AS-BUILTS

DESIGNED BY: JMF/JAC	PROJECT: BOTETOURT COUNTY, VIRGINIA PHASE I TINKER CREEK SANITARY SEWER INTERCEPTOR IMPROVEMENTS	REVISION SET 2
DRAWN BY: WSW/CLP	TITLE: GENERAL NOTES AND SHEET LAYOUT	DRAWING NUMBER: G-1
CHECKED BY: EJTP	FILE NAME: 1036G-1.dwg	SHEET NUMBER: 2 OF 23
WWA NUMBER: 211036.02	DISCIPLINE: GENERAL	
	SCALE: H: AS NOTED V: AS NOTED	
	DATE: 7-15-11

Request For Information

Job: 1570 Ph I Tinker Creek Sewer Improv

Work Change Directive

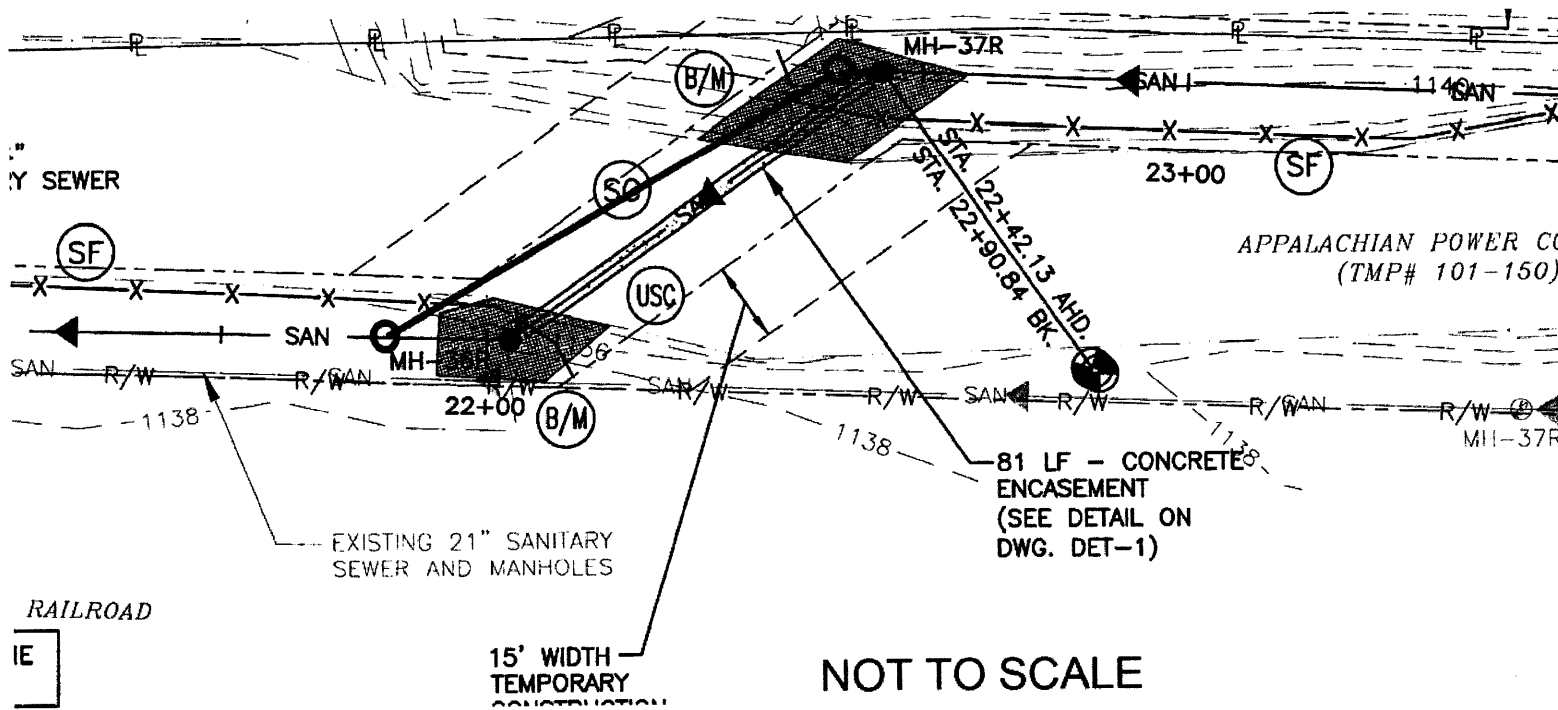
Item No.	Description
1	Shift MH 36R to STA 21+81 +/- INV IN will remain 1128.84. INV OUT will remain 1128.74
2	Shift MH 37R downstream 5 +/- feet. This shift shall be in the same linear alignment as the proposed section between MH 37R and MH 38B. Inverts shall be consistent with RFI #6 response.

DRAWING NUMBER: C-2

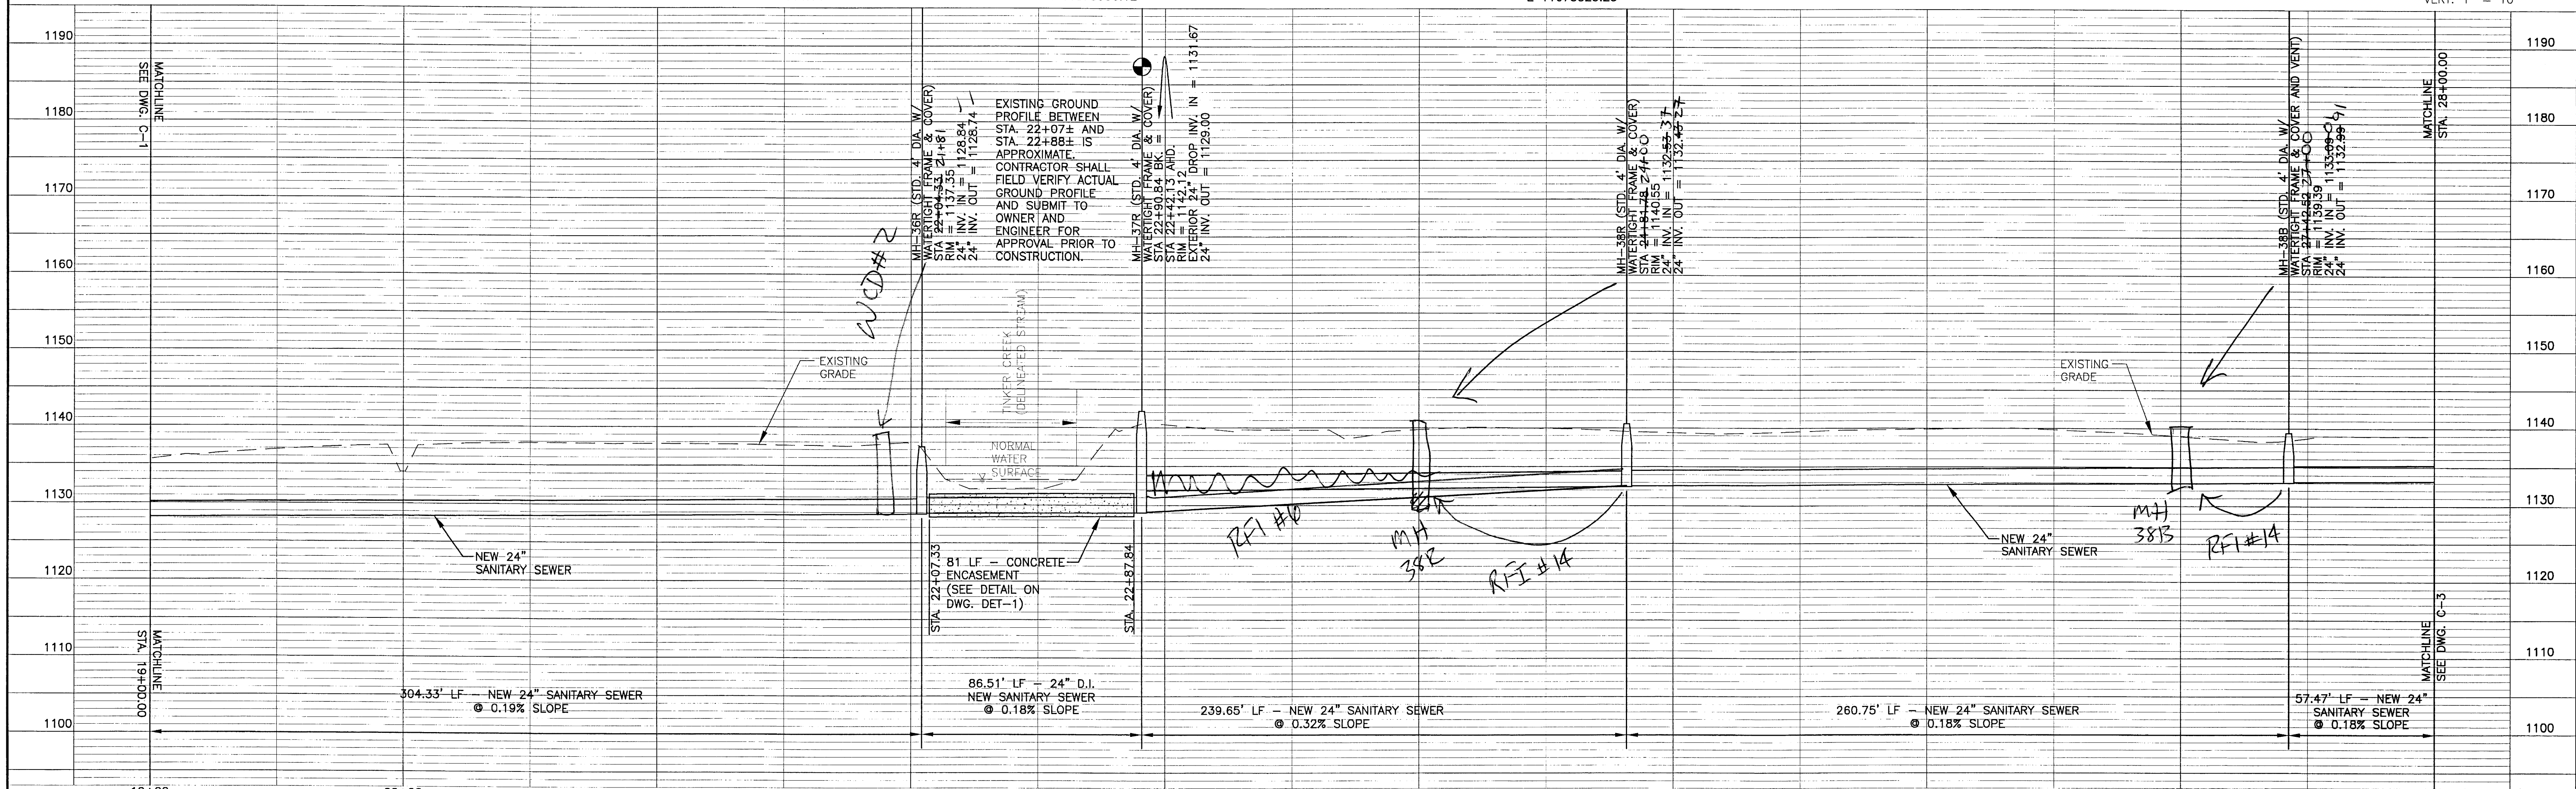
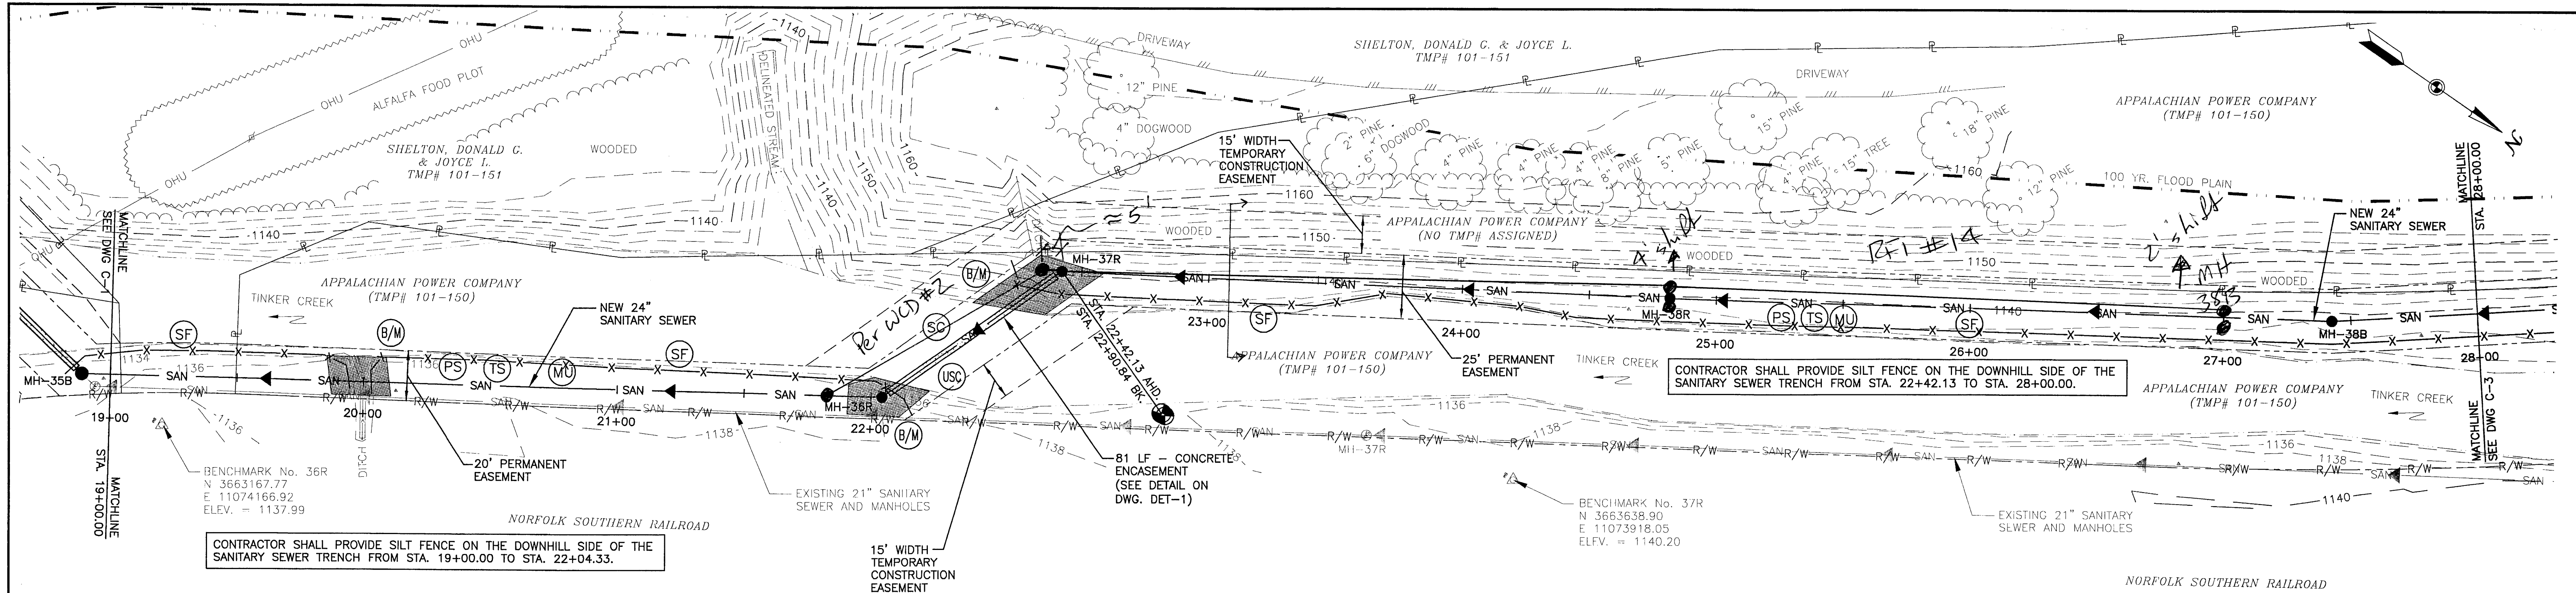
Subject: Gravity Sewer Alignment Issue

We have encountered an issue with the alignment of the gravity sewer being partially in the creek. We feel that alignment of the gravity sewer should be adjusted to keep the line from being exposed from erosion from the creek. After a field visit confirmed the issue we feel that the best course of action would likely be to re-align the manholes 38R and 38B. Moving MH-38R downstream to Station 24+00 and shifting it 4 feet away from the creek and moving MH-38B to Station 27+00 and shifting it 2 feet towards the creek could be a possible solution. Please direct us and let us know how we are to proceed with the work.

We agree with your assessment. Unstable creek bank conditions may necessitate minor alignment changes. Please take the following actions:

Place MH-38R at Station 24+00 and 4 feet off the planned alignment, shifted away from the creek. Make the INV IN 1132.37 and INV OUT 1132.27.

Place MH-38B at Station 27+00 and 2 feet off the planned alignment, shifted towards the creek. Make the INV IN 1133.01 and

INV OUT 1132.91.

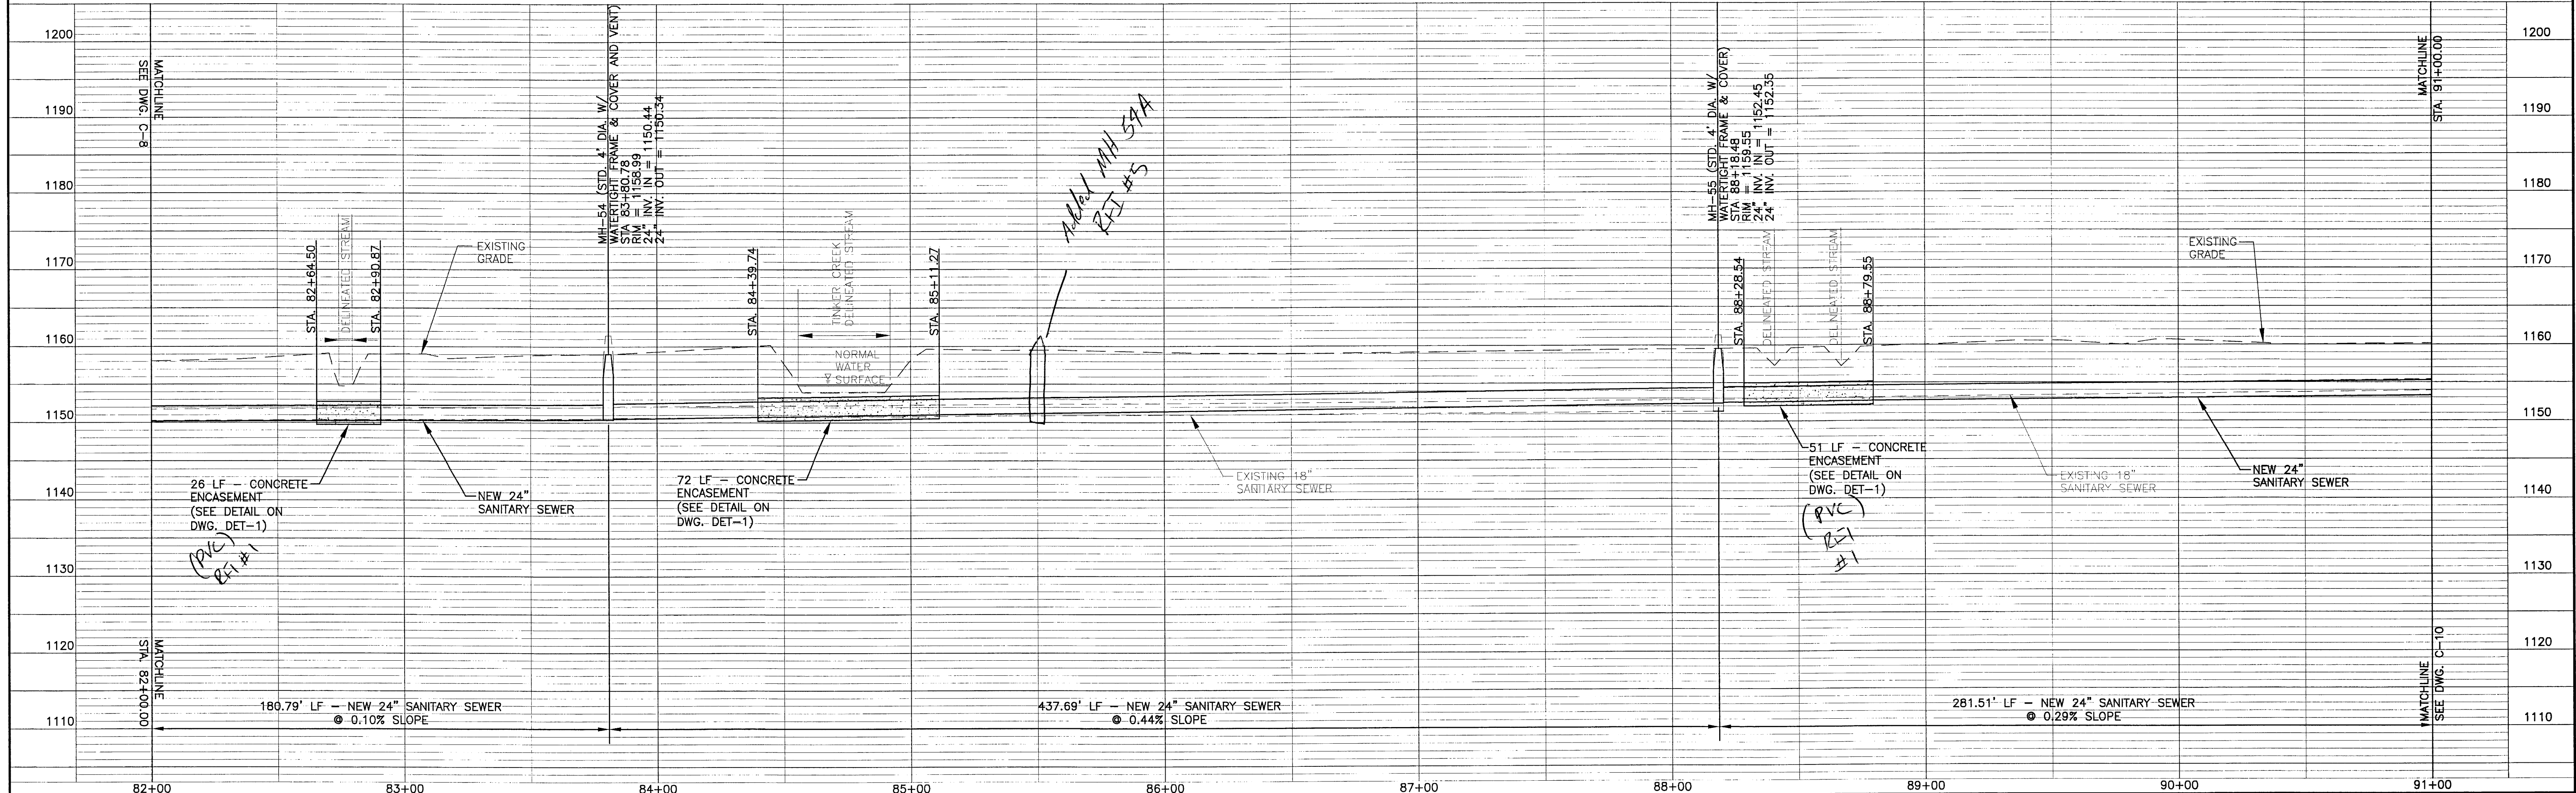
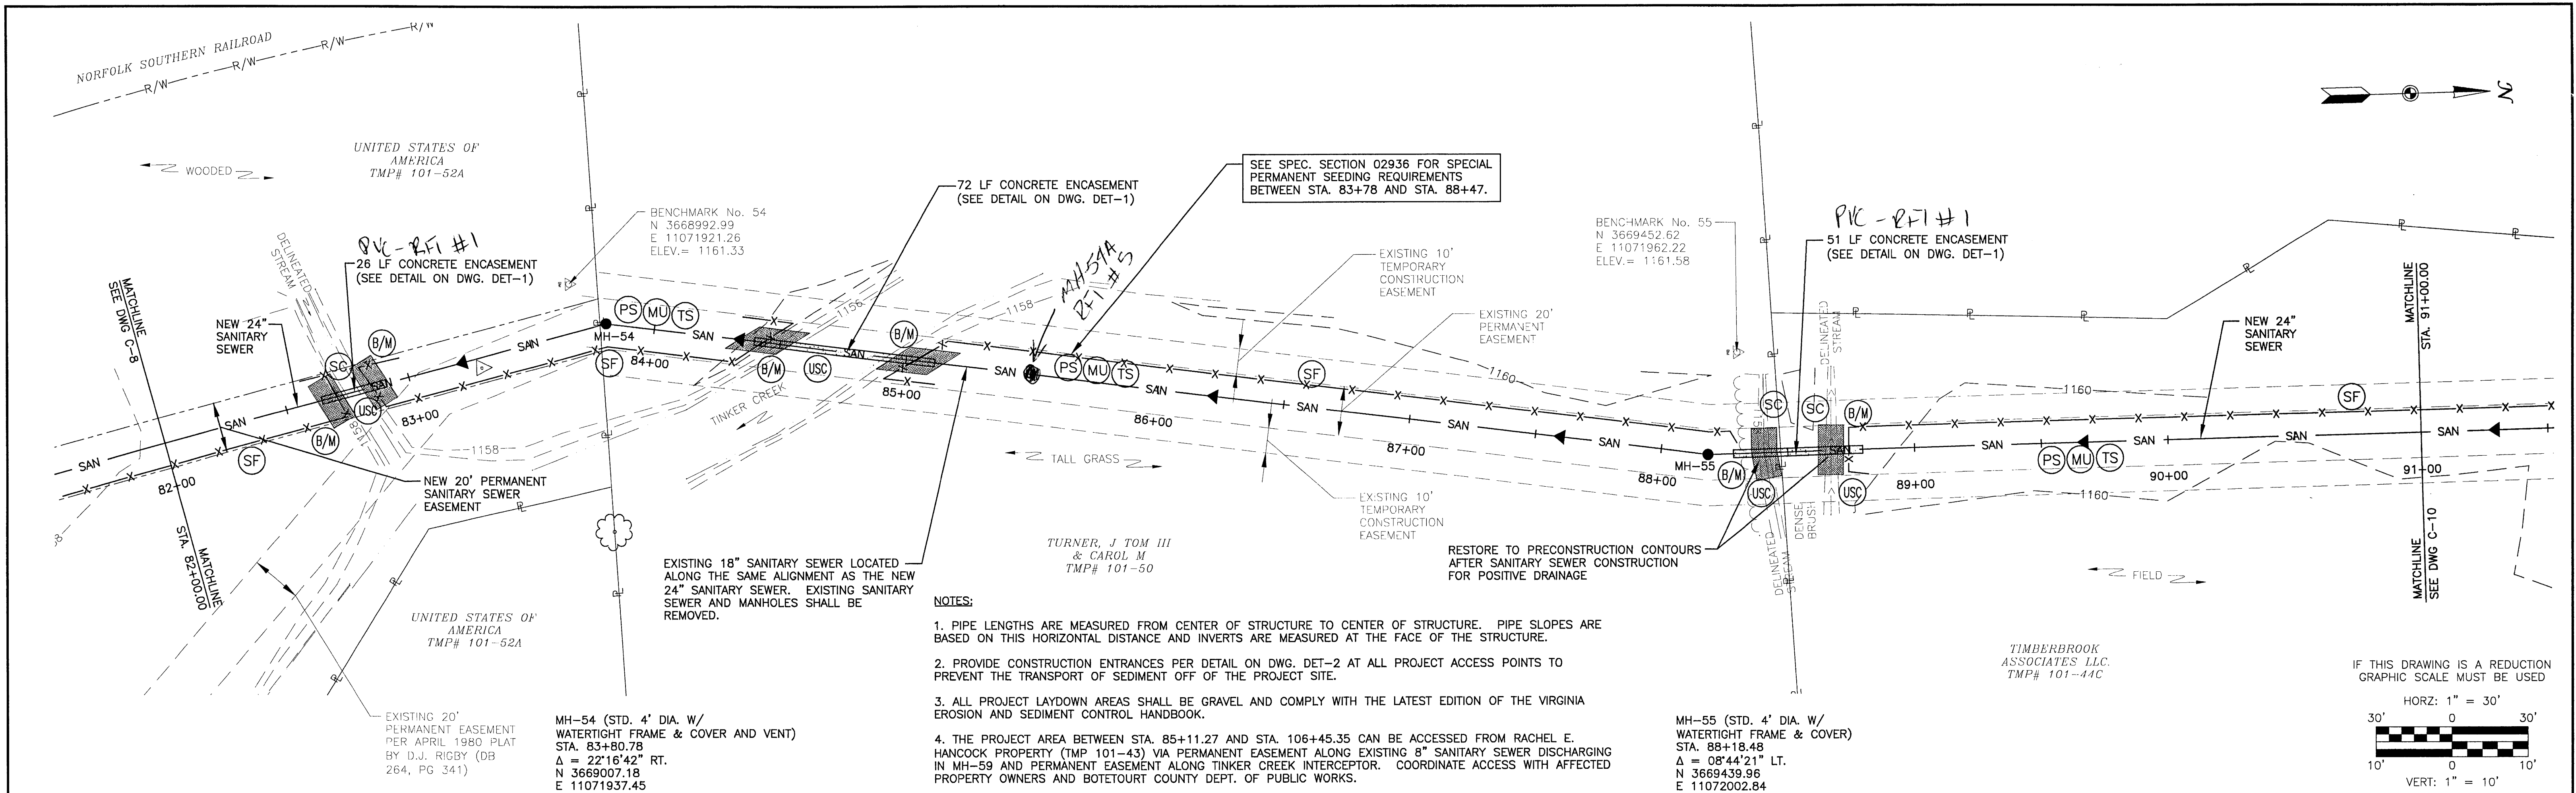
Would it be possible for the Ductile Iron piping to be changed from Class 52 to Class 50 in the crossings and through the bores? Also, we think it would be beneficial to add a manhole just beyond the Tinker Creek Crossing at approximately Station 85+50. In doing this we would be able to lay Ductile Iron Pipe to that new manhole and we would be able to leave that manhole to MH-55 with the PVC pipe. This way we would not have to transition from Ductile Iron to PVC piping in between MH-54 and MH-55. This was also discussed on the delineated stream crossings where it was determined that it is better to stay with the same type of pipe versus transitioning the pipe.

Class 50 ductile iron pipe will be allowed in lieu of Class 52 ductile iron pipe for creek crossing and as carrier pipe through steel casing pipes.

A manhole located at Sta. 85+50.00 will be allowed per the Contractor's request. The manhole shall be installed as follows:

MH 54A (Std. 4' Dia.)
Sta. 85+50.00
Rim Elev. = 1159.50
24" Inv. In = 1151.24
24" Inv. out = 1151.14

To account for the 0.10-foot drop required between the invert in and out of MH-54A, the slope of the sanitary sewer from MH-54 to Mh54A, and from Mh-54A to Mh-55 will need to be 0.14%.
